Revisions to the Agenda

City Council review of the Planning Administrator's decision for Phased Subdivision / Class 2 Adjustment Case No. SUB-ADJ17-09 for property located at the 3700 and 3800 Blocks of Dogwood Drive S.

MEMORANDUM

SUBJECT: Additional Attachments for Agenda Item 4.a for Meeting of December 4, 2017

PRELIMINARY PLAN
COVER SHEET

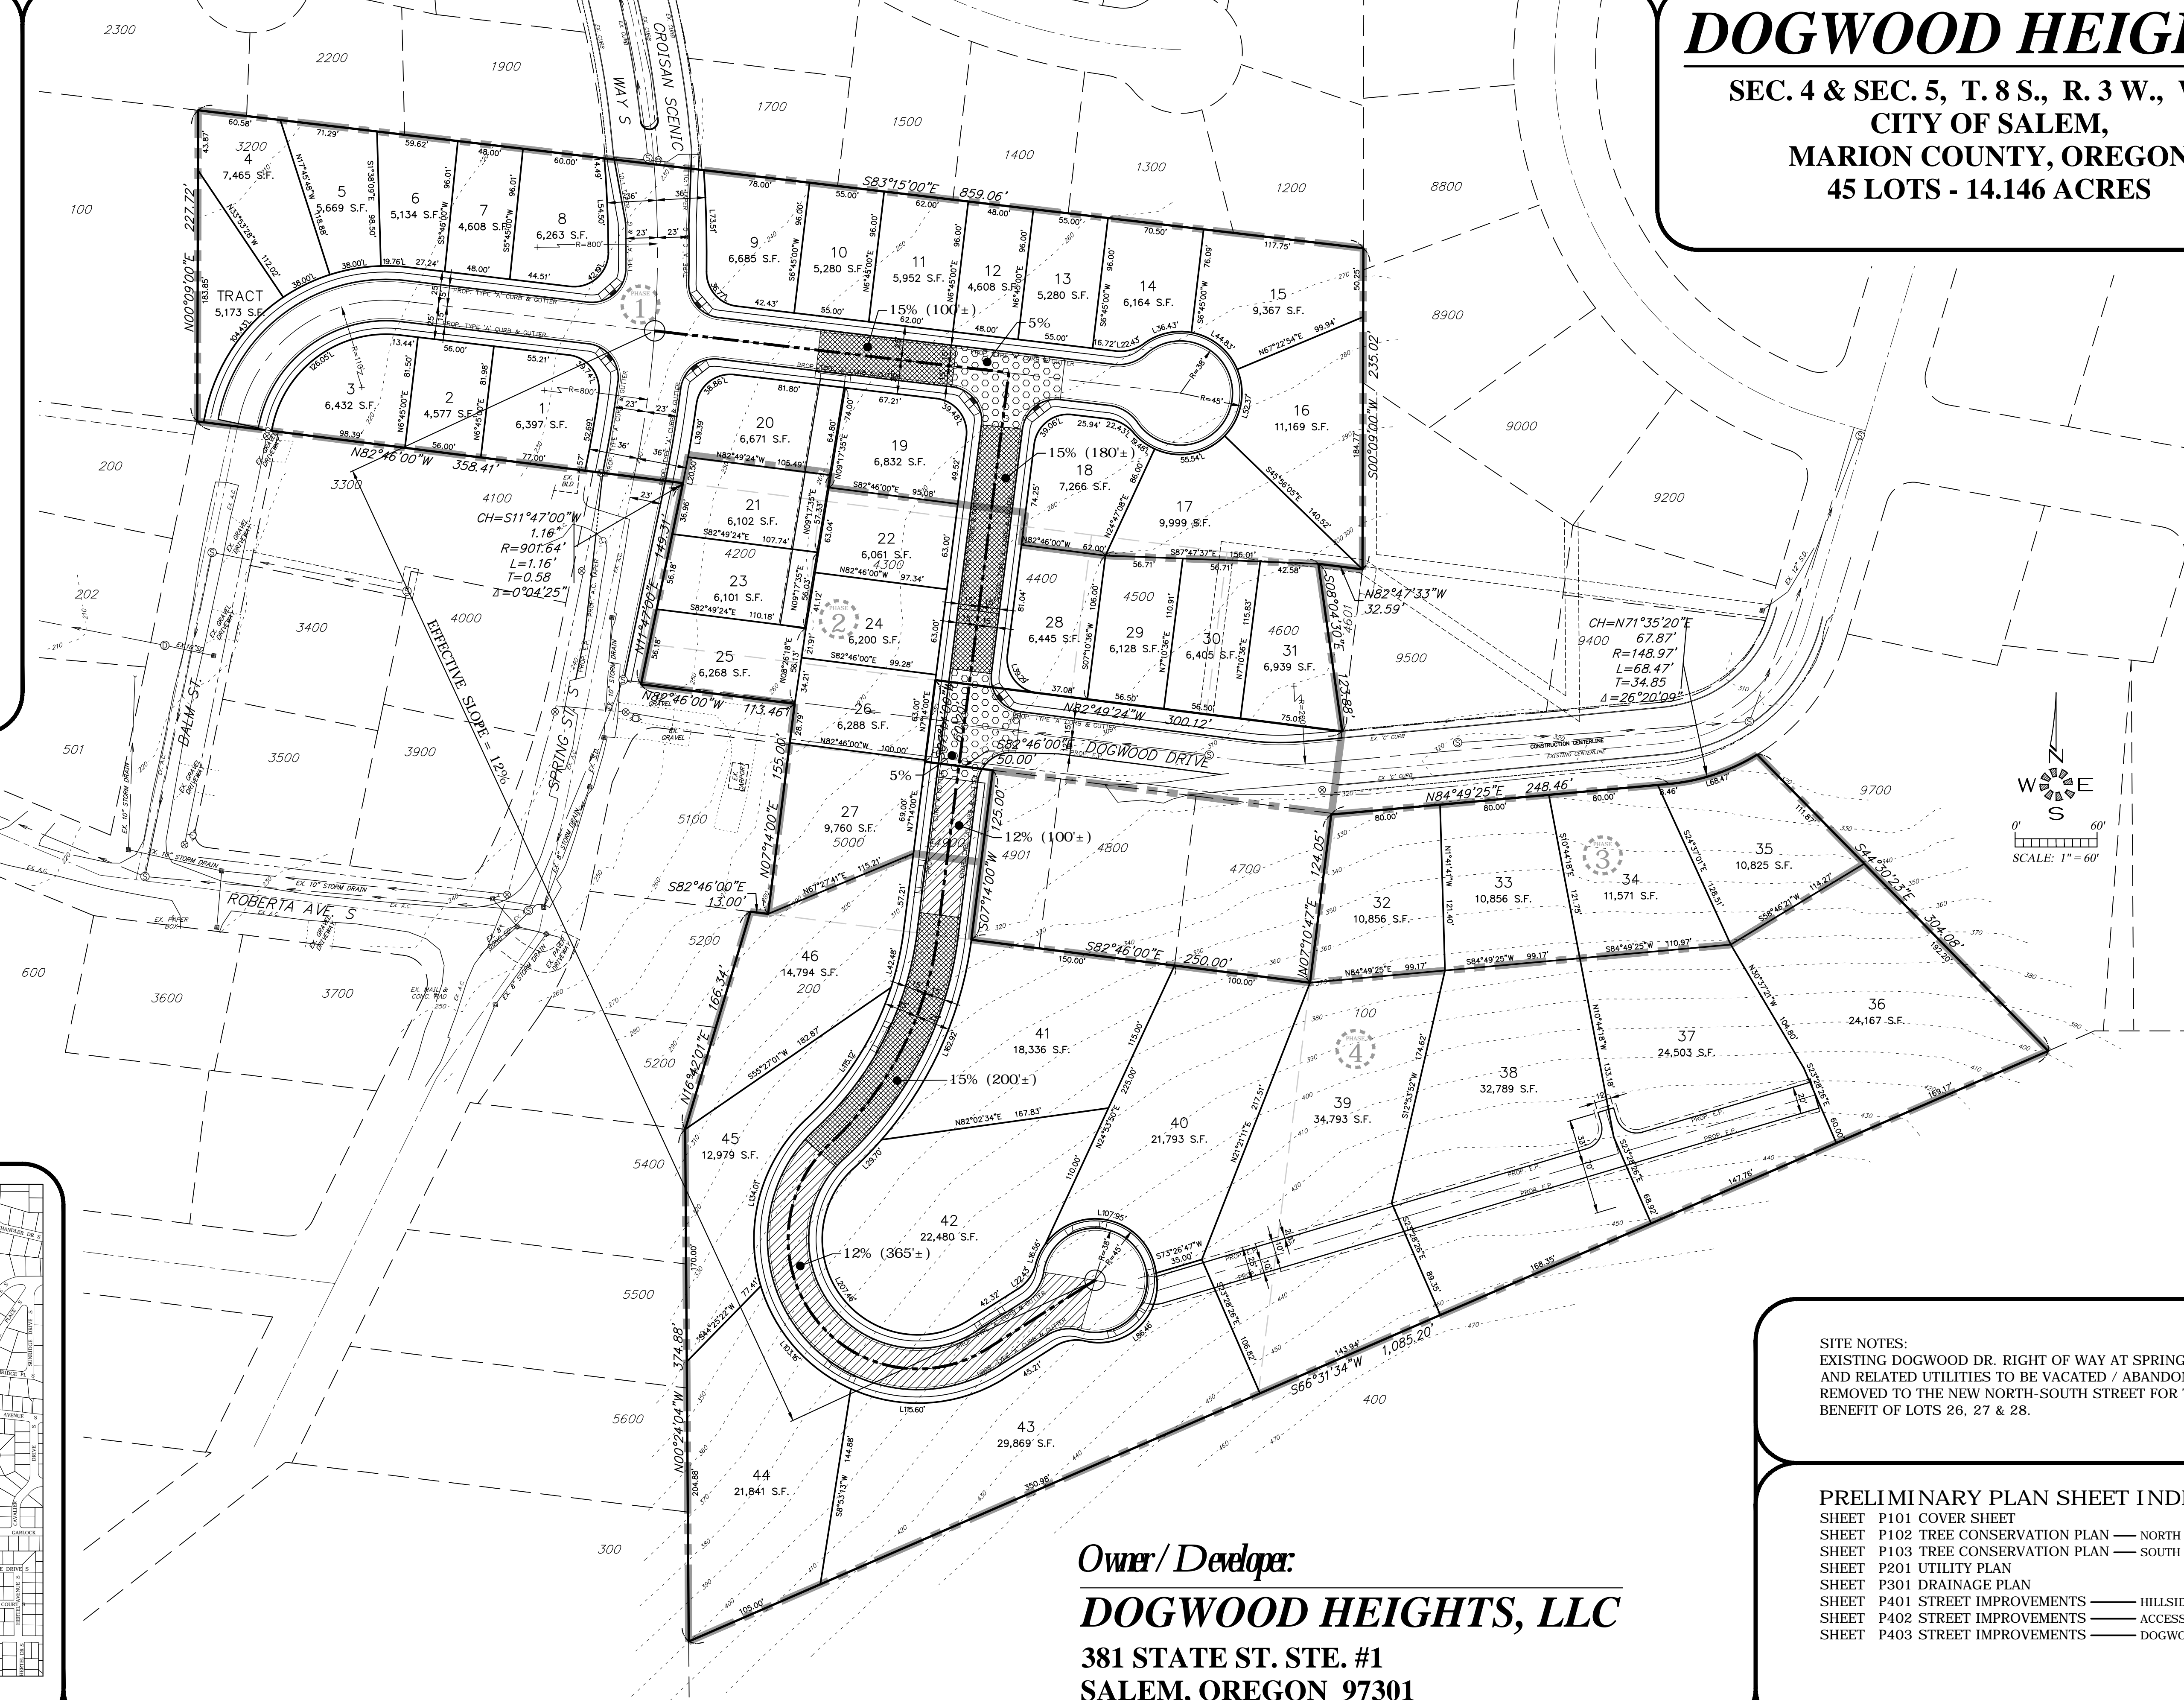
The applicant is requesting a Class-2 Adjustment to allow the new streets with the proposed Dogwood Heights project to exceed a 12-percent street grade in the areas denoted on Sheet P101.

(A) The applicant is requesting an adjustment to street grades. As shown on the Preliminary Plan Cover Sheet, P101 and detailed on the street section provided (Sheet P401), the above-mentioned streets will have sections of the roadway with a 15% street grade. Due to the topography of the site and the proposed street alignment with existing streets, this street will exceed 12% street grade. The areas proposed for slopes in excess of 12% are denoted on the plans and will not exceed a single run length of 200 feet.
